MCDONALD'S RESTAURANT

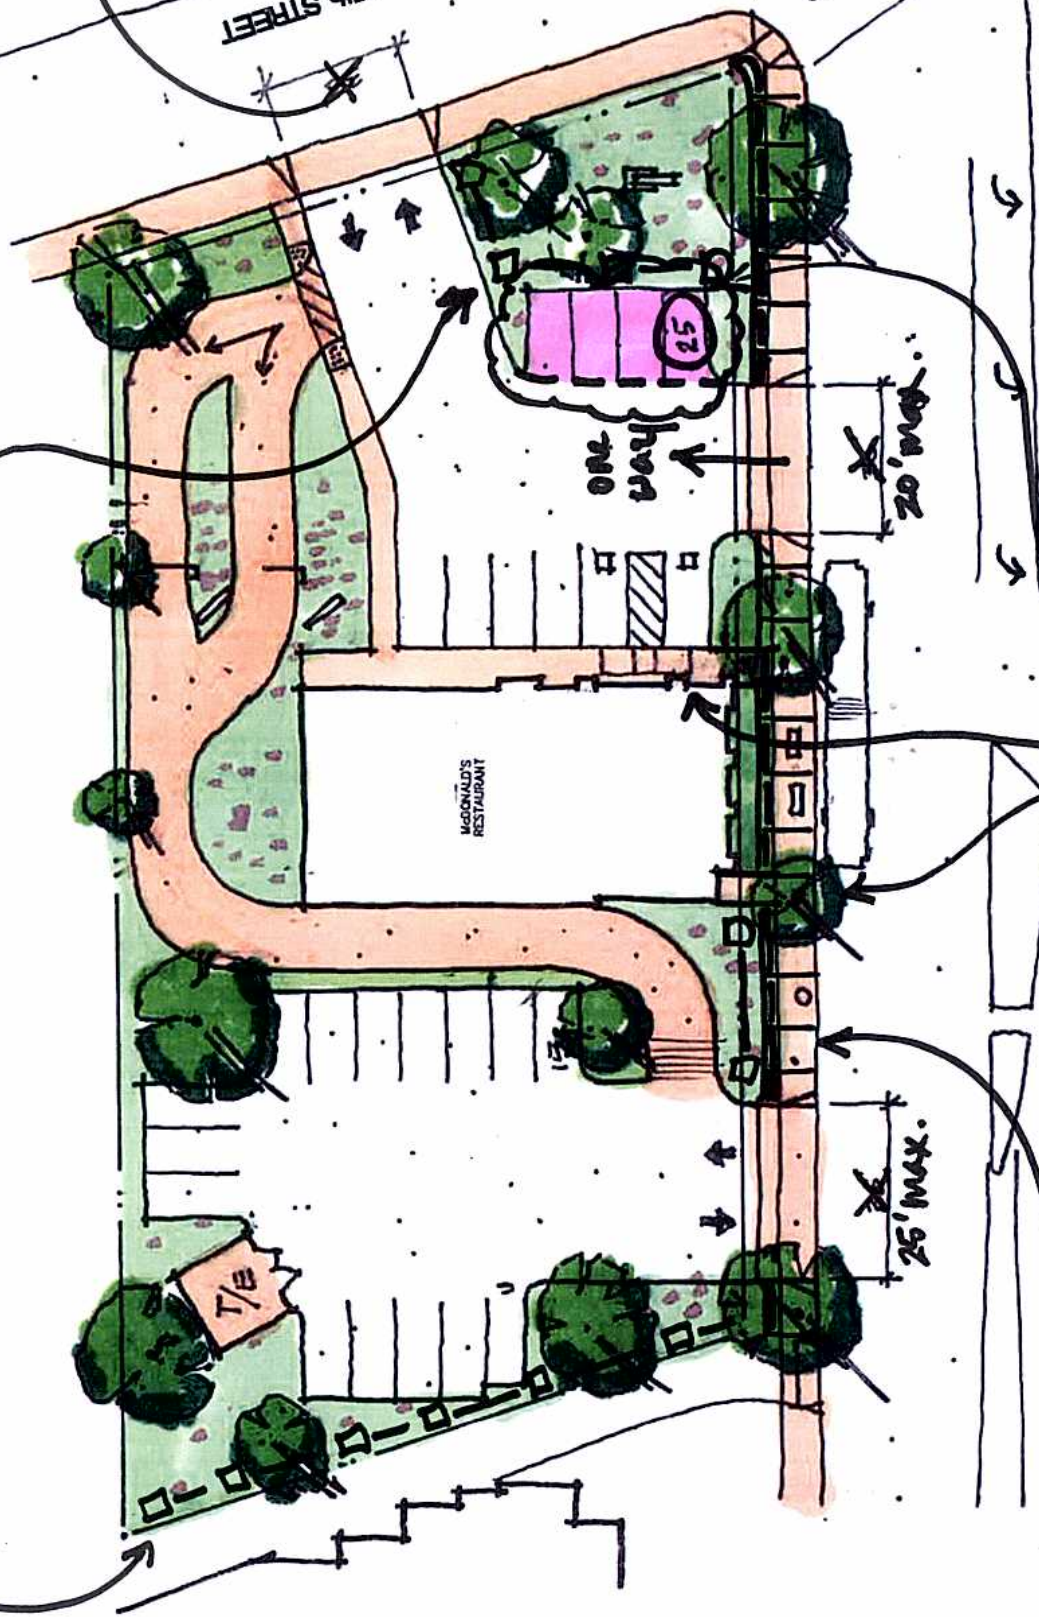
Add decorative low fencing and/or trellises to screen north & south parking lots.

25' max.

20' max.

25' max.

Council direction requested  
on number of spaces in South Lot

Connect entrance walkways directly to sidewalk.

Widen sidewalk along Telegraph to a minimum of 10 feet.
